## ADDENDUM No. 9

Request for Bid (RFB) 10161 – Lakeside Equestrian Facility

Addendum No. 9 forms a part of the contract documents and changes the original documents only in the manner and to the extent stated.

**BIOFILTRATION BASIN #1 SECTION**  
N.T.S.

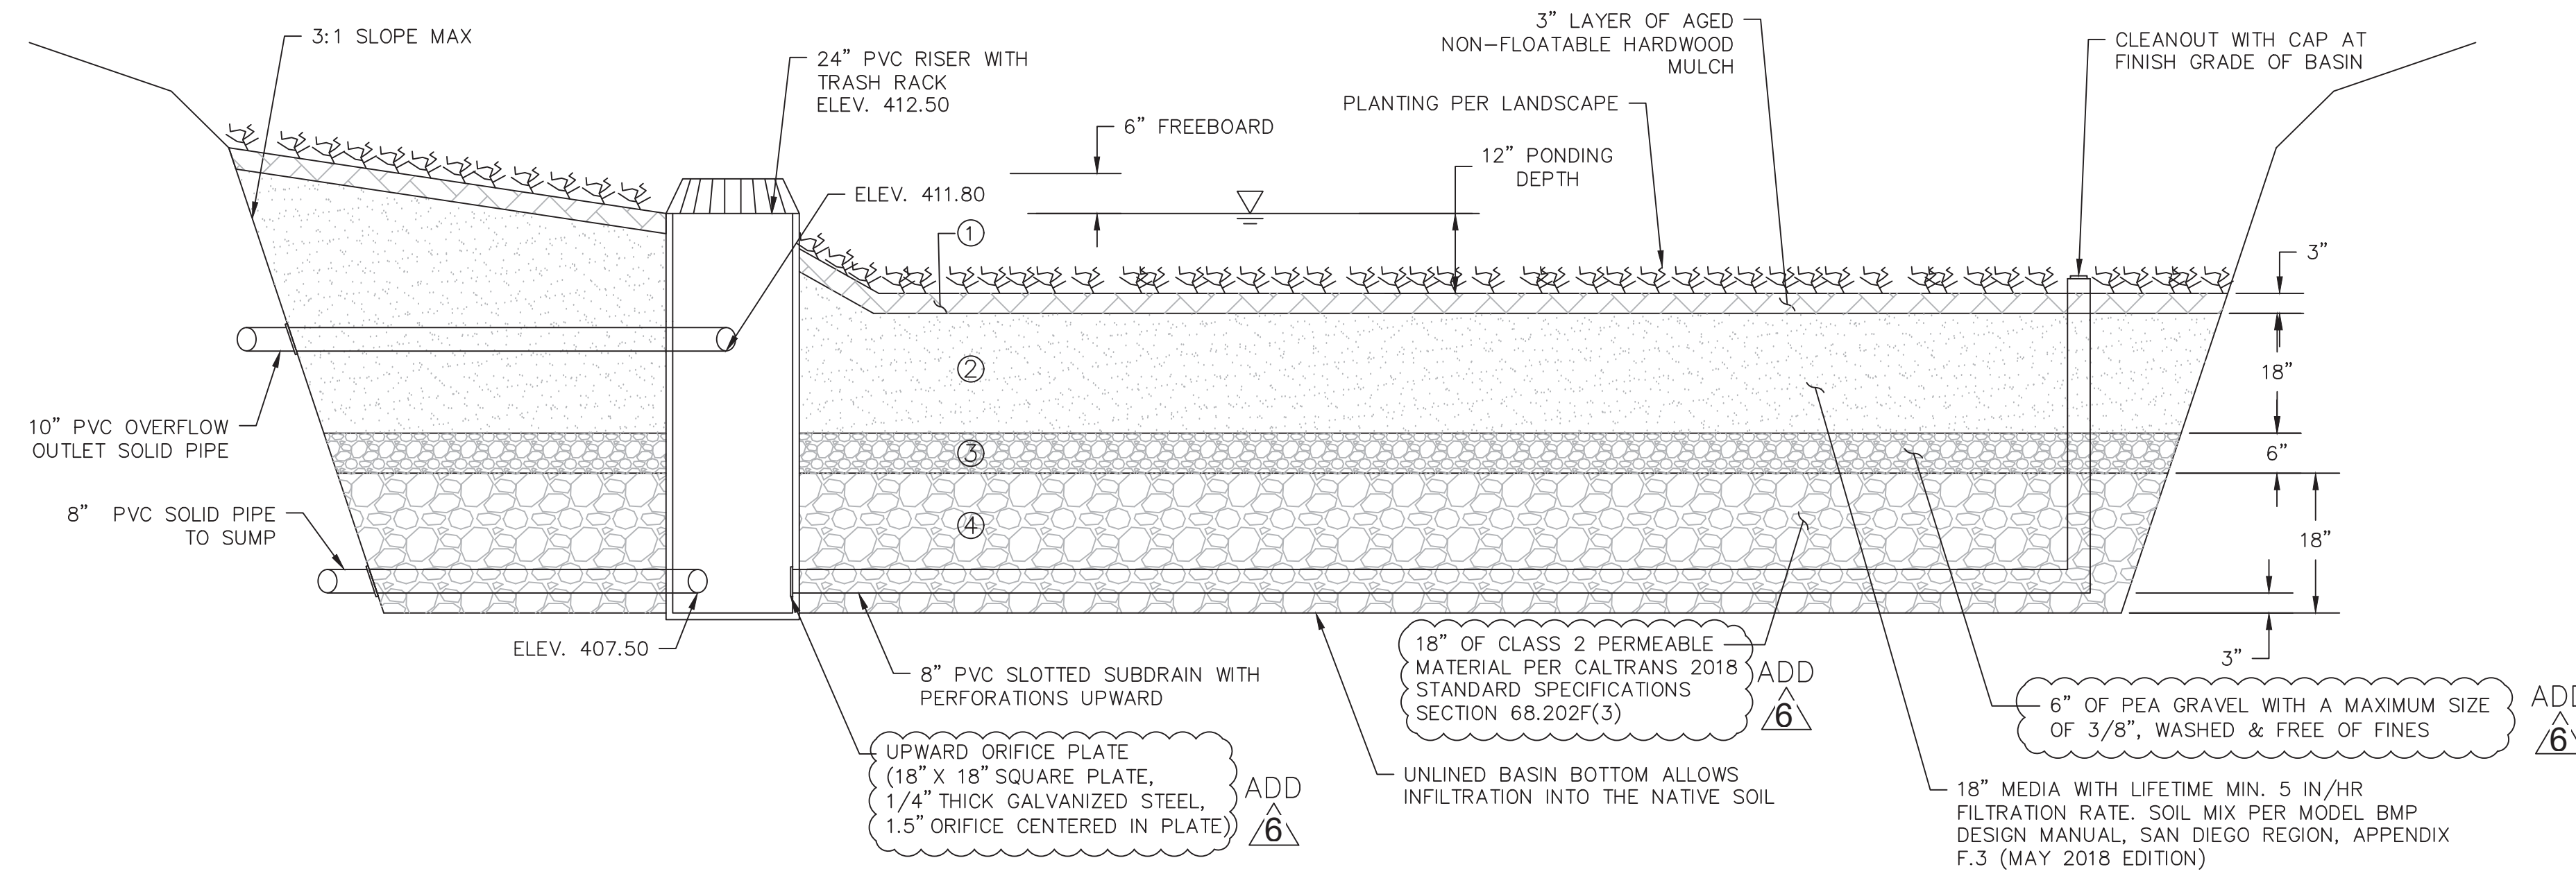
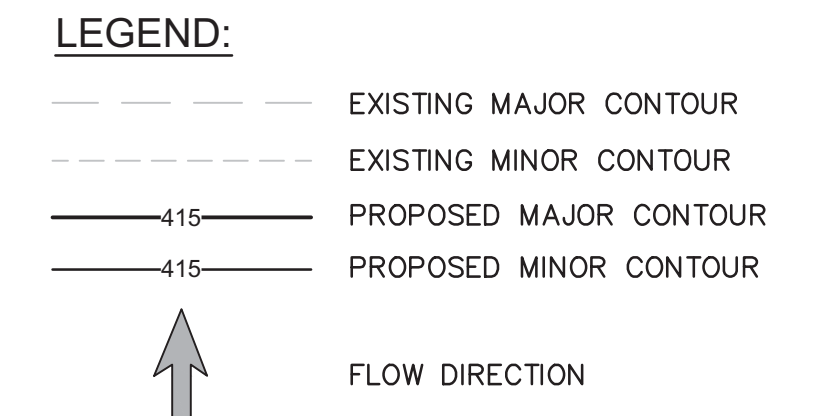
**Q8: Bid Item #40 has 828 LF of 8" PVC Perforated Subdrain. Sheet C-10, Bio Filtration Basin #1 section calls out for 8" PVC slotted subdrain. Please advise if perforated or slotted is to be installed.**

**Q9: This question is the same for all bio basin line items for 8" PVC Slotted. Please advise if quantities are correct. Plans show different linear footages.**

A8: *Use 8" PVC slotted pipe. From the storm water manual:*

A9: *The Total Linear Feet Shown is a combination of Slotted and Solid Pipe lengths.*

8" PVC	8" PVC	8" PVC	
	Slotted	Solid	Total	Notes
Biobasin 1	436	392	828	Bid Item #40 shows 828 LF Total
Biobasin 2	34	16	50	
Biobasin 3	177	0	177	
	<b>647</b>	<b>408</b>	<b>1055</b>

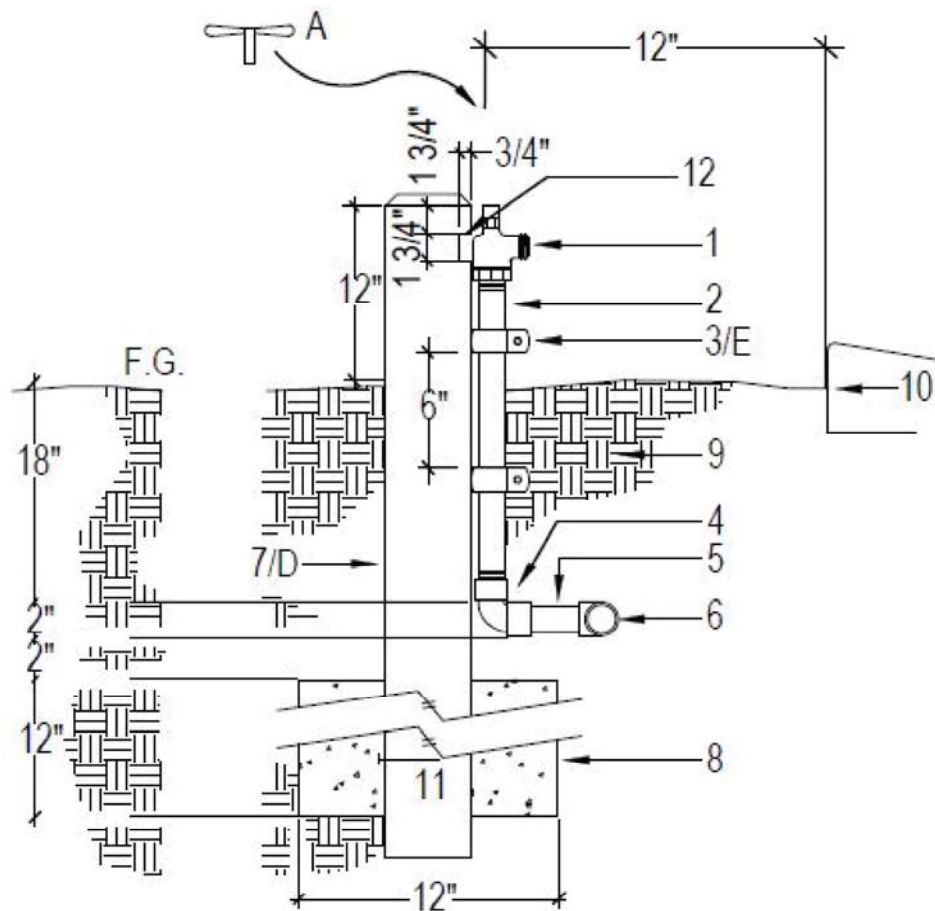
**Q17: Please provide a detail or specifications for the water spigots.**

*A17: Refer to water spigot detail attached to this addendum.*
